ZONING PLAN
FOR
SHALLOWFORD PLACE
LOCATED IN LAND LOT 400
16TH DISTRICT, COBB COUNTY, GEORGIA

PETITION NO: Z-111

Z-111-2016 GIS

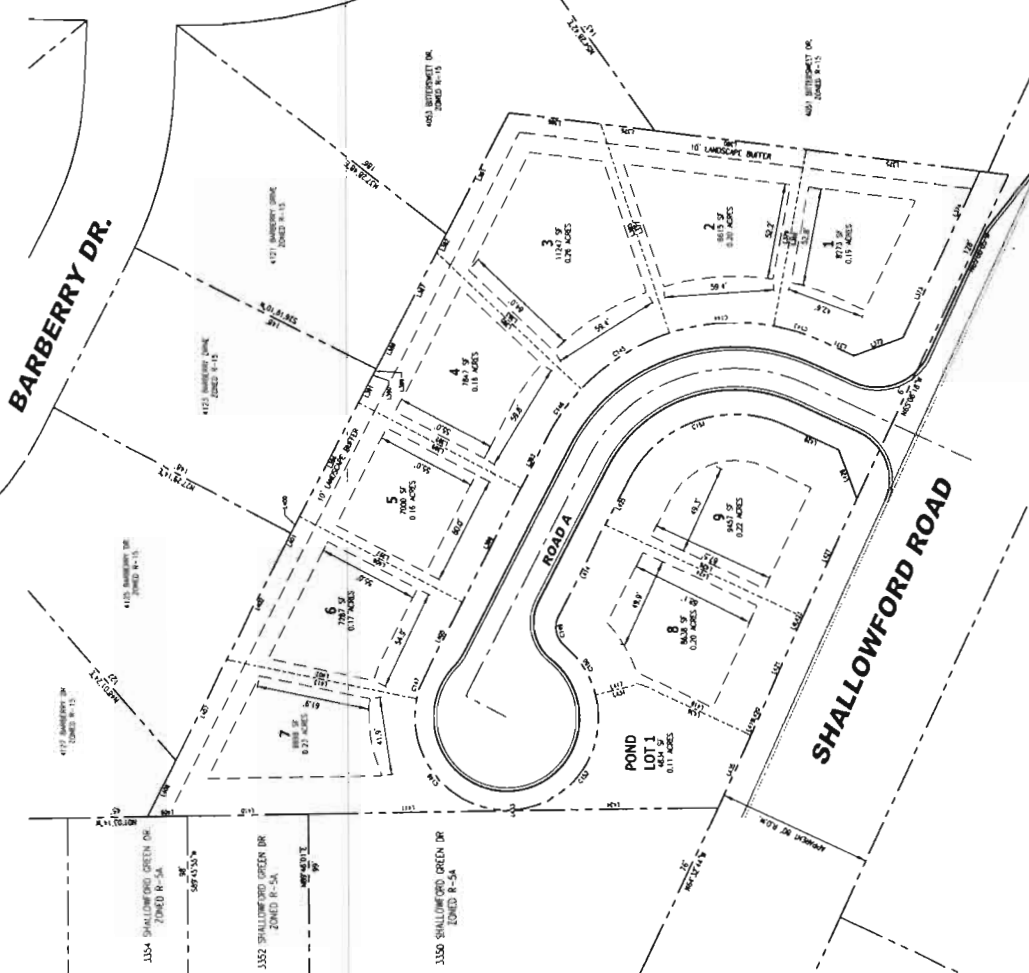
The applicant is requesting a rezoning to the RA-5 single-family residential district in order to develop nine (9) detached single-family homes. That district's minimum lot size of 7,000 sq. ft. will be met with the lots ranging from 7,000 sq. ft. to 11,247 sq. ft. The proposed homes will be a minimum of 2,500 square feet and be constructed with brick, stone, stacked stone, cedar shake, board and batten, or combinations thereof. Anticipated selling prices will be starting in the high \$500,000s. The Code-required 10 foot landscape buffer is provided adjacent to more restrictively zoned (R-15) properties.

If approved, the following contemporaneous variance are needed:

1. Waive the rear setback from the required 40 feet to 20 feet with an increase of the front setback from the required 20 feet to 25 feet.

1. This site is located just north of Shallowford Road and is bounded on the north and east by Hedgerow Subdivision and on the west by Shallowford Green Subdivision. Slopes on the site are relatively mild ranging from 2 to 10%. The majority of the site (2/3) drains to the Shallowford Road R/W. The remaining third drains to the east into the Hedgerow Subdivision Recreation Area.
2. Any bypass runoff from the rear of lots 1 through 7 must be directed to the Shallowford Road right-of-way and not to the Hedgerow Rec Area.

Shallowford Road is classified as an arterial and according to the available information the existing right-of-way does not meet the minimum requirements for this classification.

Recommend applicant consider entering into a development agreement pursuant to O.C.G.A. 36-71-13 for dedication of the following system improvements to mitigate traffic concerns: a) donation of right-of-way on the north side of Shallowford Road, a minimum of 50' from the roadway centerline.

Recommend curb and gutter along both sides and sidewalk along one side of proposed development roadway.

Recommend guest parking be located outside of the right-of-way.

1. Site plan received by Zoning Division on October 6, 2016 with District Commissioner approving minor modifications;
2. Fire Department comments and recommendations;
3. Water and Sewer Division comments and recommendations;
4. Stormwater Management Division comments and recommendations;
5. Department of Transportation comments and recommendations;
6. Owner/developer to enter into a Development Agreement pursuant to O.C.G.A. §36-71-13 for dedication of system improvements to mitigate traffic concerns; and
7. House architecture to be approved by the District Commissioner.
